MEMORANDUM

SUBJECT: **Demolition Permit Application**
10 Ruggles Avenue, Thornhill (Langstaff) - Munshaw House
Fire Damage

FILE: 24 179349 DP

GROUND FL DEMISED WALL

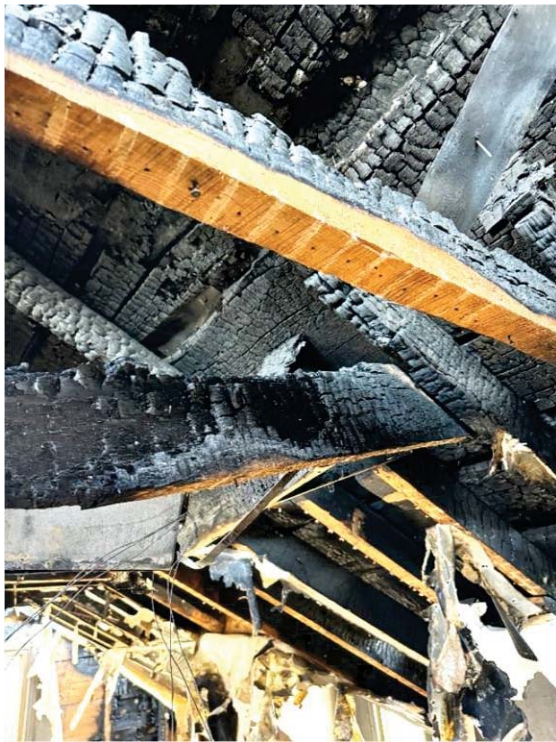
Areas of the ground floor sheathing were found to have been missing or lost to the fire, specifically in the east half; visible douglas fir floor joists were found to have sustained moderate to severe damage. Areas of original lathe and plaster at the north elevation and the north south interior demised wall were found to have been lost to the fire; the douglas fir stud framing members, including the bottom and top plates were found to have sustained severe damage and areas of total loss.
